SUBMITTAL IDENTIFICATION SHEET

PROJECT: 15051-Webster University Interdisciplinary Science Building

RE: Motorized Roller Window Shades Product
Data

**MOTORIZED WINDOW SHADES
SHOP DRAWING SUBMITTAL
SECTION: 122413**

3% OPEN SHEER FABRIC

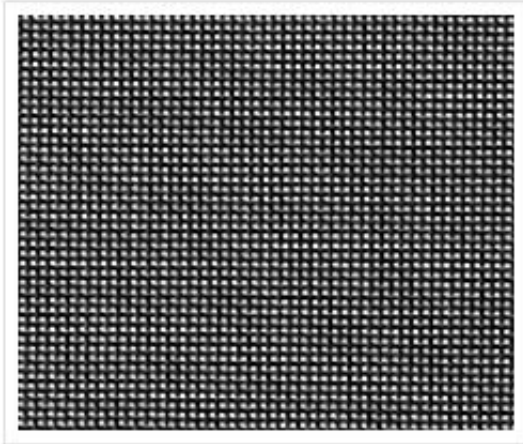
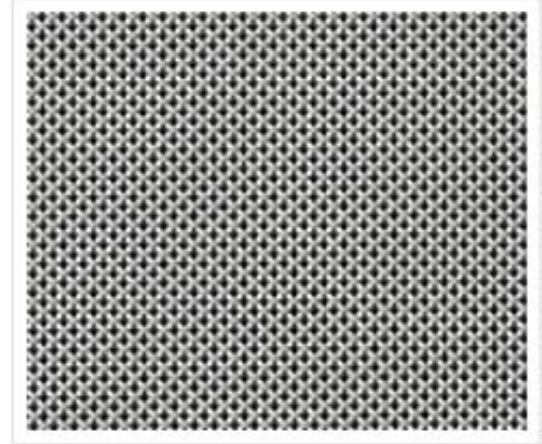
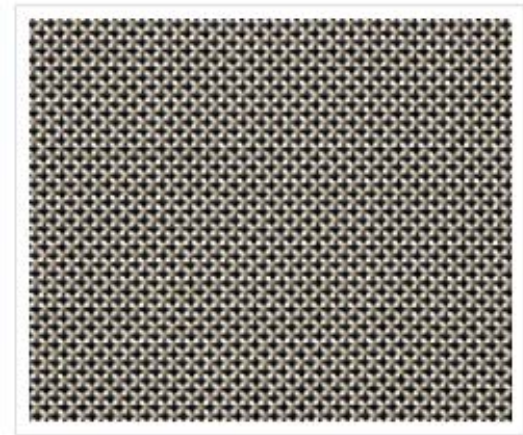
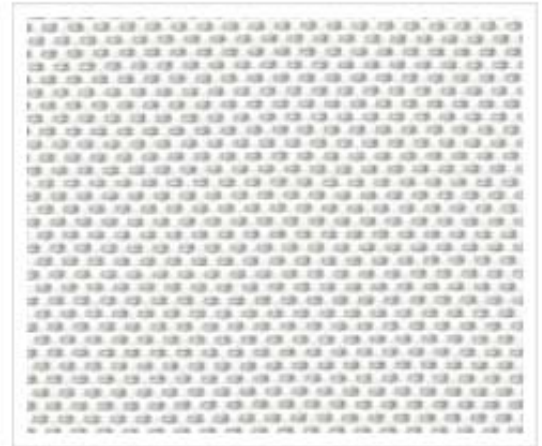
Architect, please select colors you would like to see a physical color sample of.
- dg

PROVIDE 12" X 12" SAMPLES OF ALL SHADE FABRICS FOR SELECTION INCLUDE LUTRON BASKETWEAVE , BASKETWEAVE 27, BASKETWEAVE 4000 ECO, BASKETWEAVE 90, BASKETWEAVE E SCREEN.BASKETWEAVE MS IN ADDITION TO SHEERLITE PROVIDE 1% AND 3% OPEN FABRICS. PLENUM RATED SHADE PANELS ARE REQUIRED: QSPS-10-PNL SURFACE MOUNTED POCKETS - NOTE CUSTOM COLOR SPECIFIED

0% BLACKOUT FABRIC

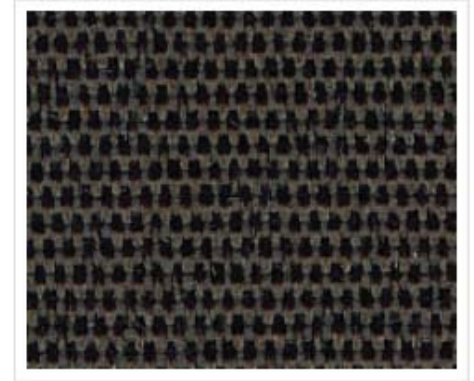
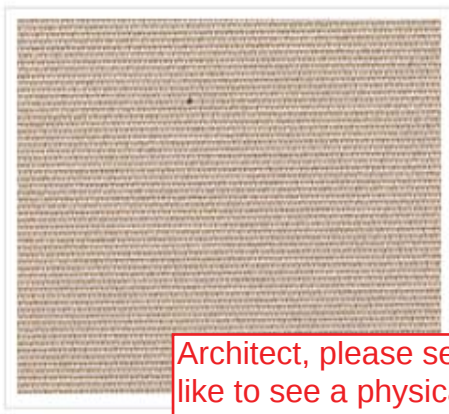
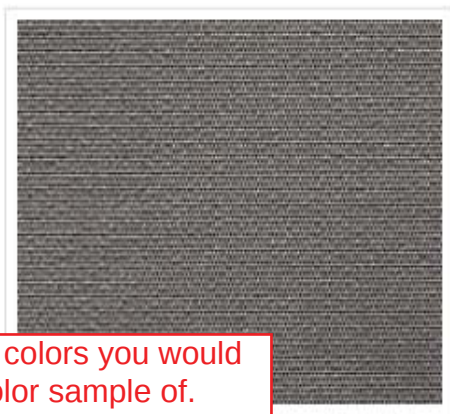
Architect, please select colors you would like to see a physical color sample of.
